From: Hall, Victor
Sent: Monday, May 04, 2015 3:10 PM
To: Carl.corbin@luminant.com
Cc: Singal, Balwant; Shams, Mohamed
Subject: Request for Additional Information: Comanche Peak Flooding Hazard Reevaluation Report (TAC Nos. MF1099 and MF1100)
Attachments: Comanche Peak Flooding RAIs - Final - May 2015.docx

Request for Additional Information
Fukushima Lessons Learned Flood Hazard Reevaluation Report
Comanche Peak Nuclear Power Plant Units 1 and 2 (TAC Nos. MF1099 and MF1100)

Figure 7-1 from Calculation F-03 - LIP flood modeling results

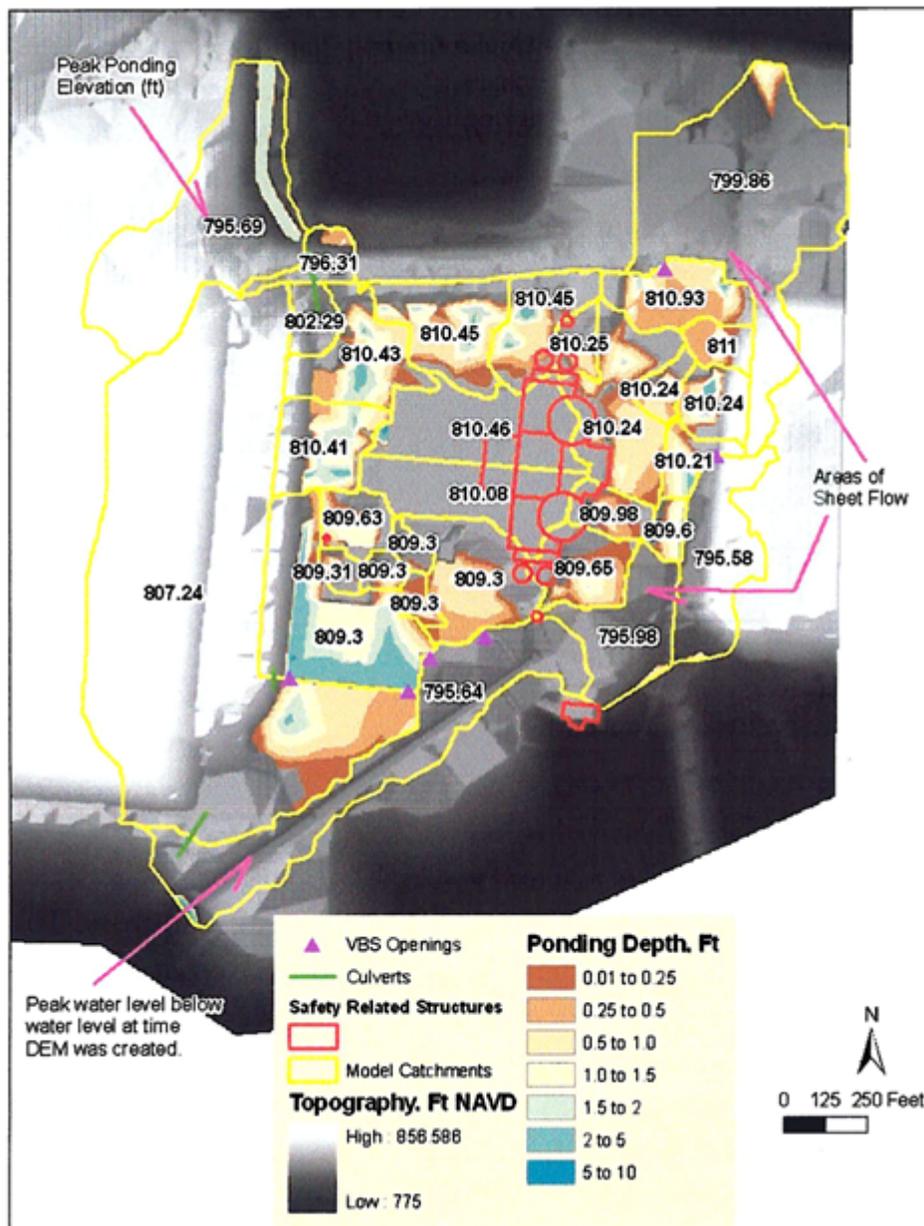
The discretization in the model appears insufficient to adequately predict flow depth and direction in critical areas around safety structures. This is evident in the elevations of the storage areas, and the routing of the flow:

Regarding elevations, the off-channel storage area capability within HEC-RAS estimates water surface elevation for each catchment based on a stage-volume curve. The model computes water surface elevation for each catchment and time-step, and it is noted that a single water surface elevation is computed for each catchment and time-step. However, the ground surface within an individual catchment contains variable elevations. The lack of resolution in the model limits the model's capability to predict flow depth and direction in critical areas around site structures important to safety.

Regarding the routing of the flow, water accumulates in areas of lowest topographic profile before exiting the catchment at the lowest elevation along the circumscribing cross sections. As such, the LIP model predicts flooding only within the lowest-profile sections of a catchment. Thus, the model does not adequately represent flooding and routing across the entire catchment, especially in areas of higher elevation. As a result, the model could not accurately predict the depth of flow and direction of flood routing since the flooding and point of discharge are located only in zones of low topographic profile.

For example, Figure 7-1 from Calculation F-03 shows a peak water surface elevation of 807.24 ft NAVD88 in the largest catchment located to the southwest. Flooding within this catchment is limited to the lowest elevation portion along the lower-right corner of the catchment. However, water could potentially pond in the upland area of this large catchment, some of which is at a ground elevation of over 850 ft. Precipitation falling onto this high elevation area has the potential to flow east to the powerblock area due to localized topographic channeling and gradient. As a result, the model may not adequately simulate temporal and spatial flood routing characteristics within and between the catchments, which could impact plant safety features.

Request: Provide an updated modeling evaluation of the LIP flood event that includes improved discretization of the plant area that is capable of better simulating temporal and spatial flow effects across the site and in the vicinity of safety structures. Provide electronic versions of any associated modeling input and output files.

Evaluate LIP flood-water inundation into the Unit 2 TB sump and condenser pit, per the previous RAI 9, based on the results from the revised model. Evaluate a variety of different LIP storm durations and distributions (see RAI 2-2). Provide a quantitative analysis of any flooding that occurs within the Electrical and Control Building due to water conveyance via the Unit 2 TB equipment ramp.
